OPTIONAL SERVICE BULLETIN NO. OSB 62-058 REV. 0

Installation of the Garmin GTX 345DR Diversity transponder with the top transponder antenna.

WORK INSTRUCTION WI-OSB 62-058 REV. 0

Installation of Garmin GTX 345DR Diversity transponder (OÄM 62-1033) for airplanes equipped with GTX 335R/ 345R, with or without Avidyne TAS 6XX(A) system.

Figure 1.

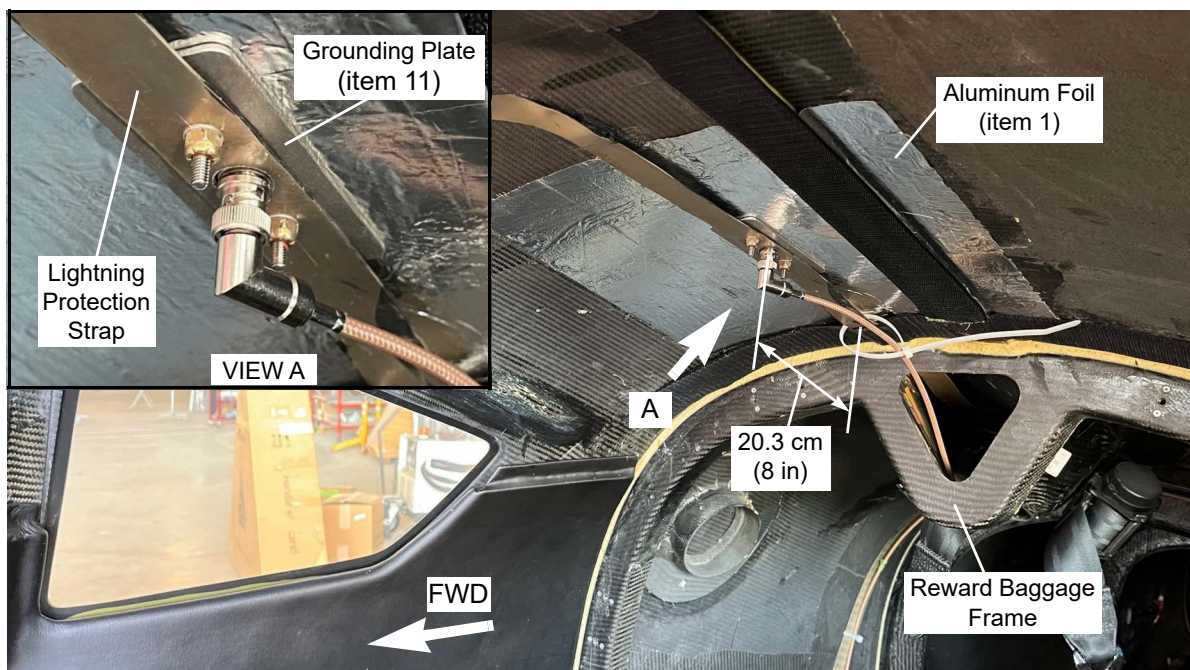
1. Incorporate AMM-TR-OÄM-62-1033 into the Airplane Maintenance Manual or use an AMM revision in which AMM-TR-OÄM-62-1033 has been incorporated.
2. Disconnect the airplane main battery. Refer to AMM Section 24-31.
3. Install the top transponder antenna as follows:
 - 3.1. To get access to the lightning protection strap on top fuselage over the RH third row passenger seat, remove the headliner.
 - 3.2. If MÄM 62-1126 is not installed, do as follows:
 - A. Mark the holes on the lightning protection strap in accordance with the hole pattern of the grounding plate (item 11), keeping the center hole 20.3 cm (8 in) from the forward-edge of the reward baggage frame.

- B. Drill holes in the airplane skins through the lightning protection strap.
- 3.3. Remove the bonding adhesive/resin from the lightning protection strap to detach it from the airplane skin along the required length to install the aluminum foil (item 1).
- 3.4. Install a 30.5 cm (12 in) x 30.5 cm (12 in) aluminum foil (item 1) using adhesive 3M Super 77 adhesive. Keep the center hole as the center point of the aluminum foil.

Figure 2.

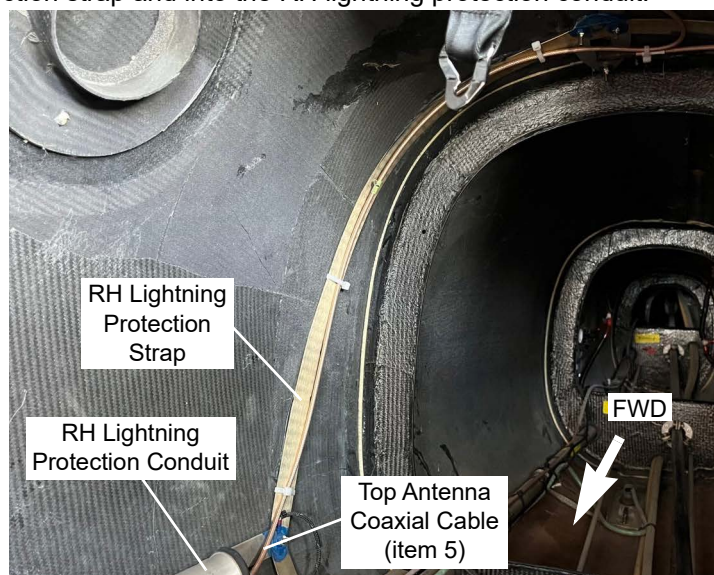
5.1. Route the coaxial cable to aft through the reward baggage frame (refer to Figure 1). Follow the RH lightning protection strap and into the RH lightning protection conduit.

- 5.2. Install the tie wrap bases (item 6) and tie wraps (item 7) to tie the top antenna coaxial cable (item 5) securely along the exposed routed length.
- 5.3. Connect the top antenna coaxial cable (item 5) to the top transponder antenna (item 4).
- 5.4. Install a tie wrap (item 7) to secure the coaxial cable (item 5) near the top transponder antenna (item 4).
6. If MÄM 62-1152 is not installed, replace the existing coaxial cable of the bottom transponder antenna with the new coaxial cable (item 12). Refer to AMM Section 92-00.
7. If GTX 345R transponder is not installed, do as follows:
 - 7.1. Remove the HIRF box cover. Refer to AMM Section 31-40.
 - 7.2. If MÄM 62-1001 is not installed, install wiring as follows:

Figure 5.

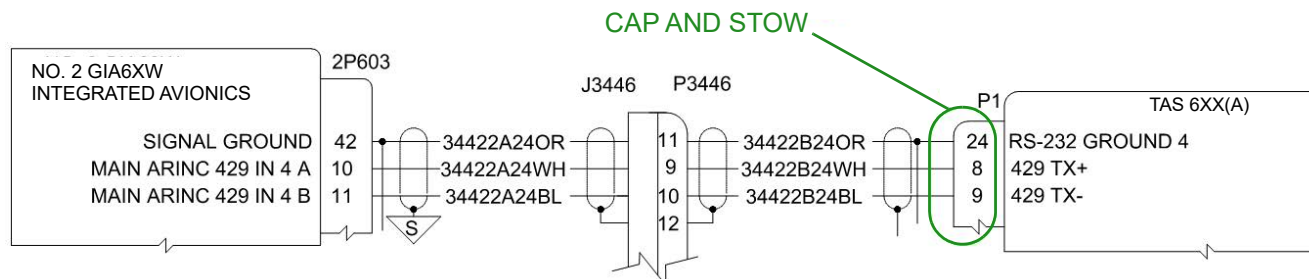
A. Cap and stow existing ARINC 429 wire.

Figure 6.

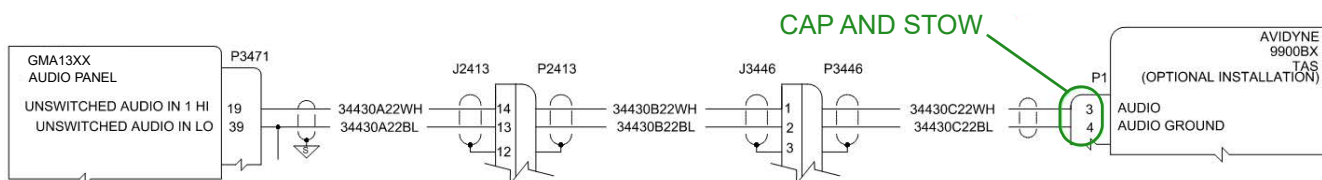
B. Cap and stow existing AUDIO wire.

Figure 8.

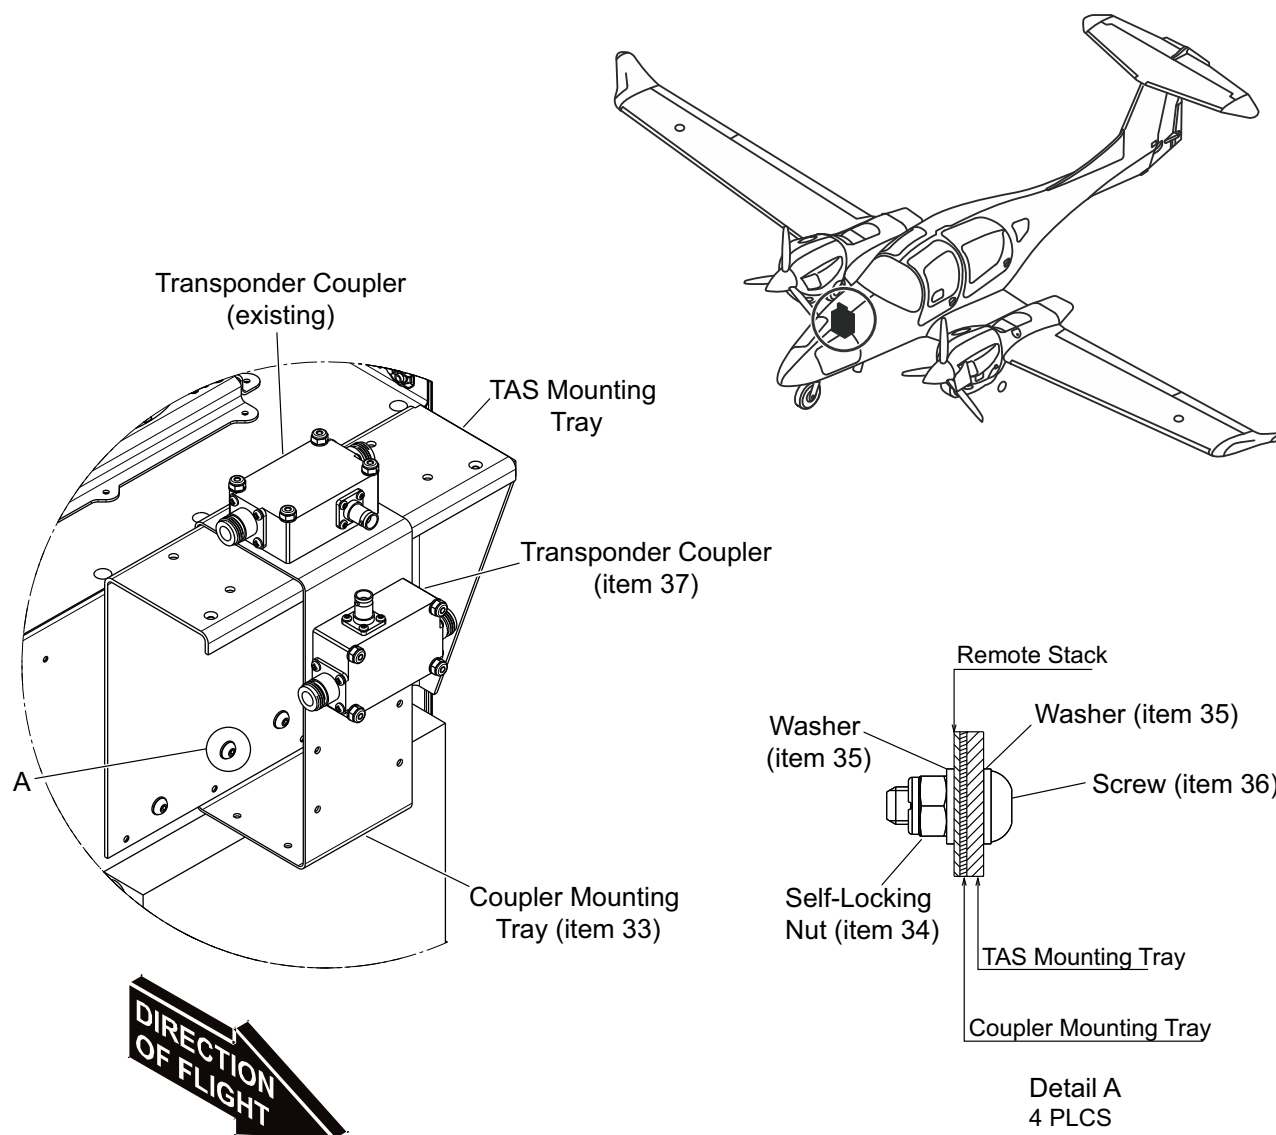
- 9.3. Install the screws (item 36), washers (item 35), and self-locking nuts (item 34) which attach the coupler mounting tray (item 33). Refer to Figure 8.

Figure 9.

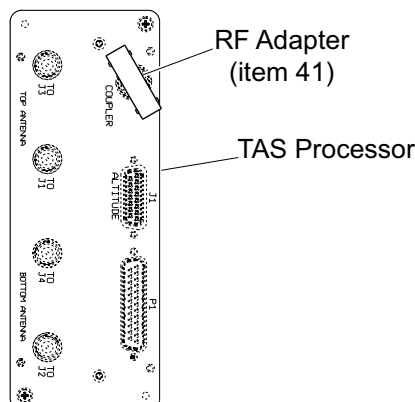
9.7. Connect the RF adapter (item 41) to the coupler receptacle on the TAS processor. Refer to figure 9.

Figure 10.

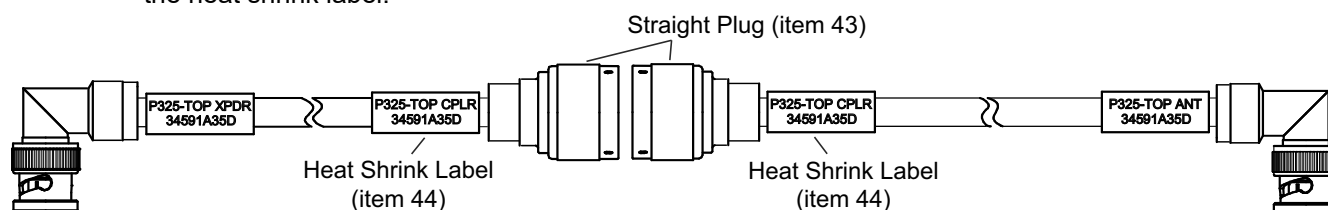
9.9. Install the heat shrink labels (item 44) on the top antenna coaxial cables (item 5). Record the text on the heat shrink label.
